Date: 01/09/2020
To: Billy Barnard (Signature Builders)
From: Paul Spears, PE
Subject: Comments on Failed Inspection at
2921 NW Thoreau Drive (Permit #PRRES20192732)

FROM S101

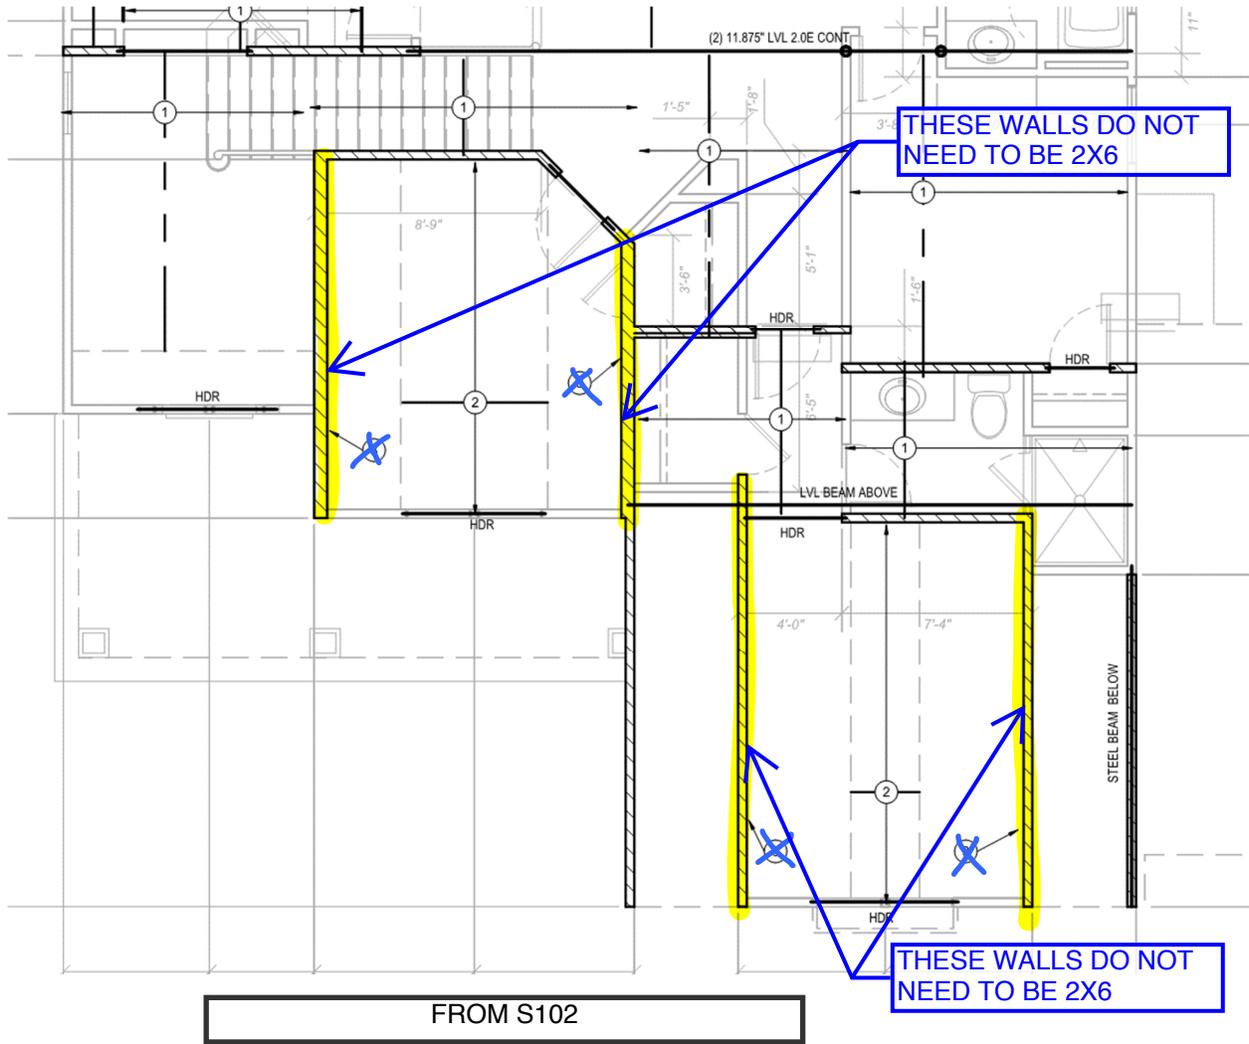
The following walls do not need to be 2x6 walls, 2x4 are acceptable.
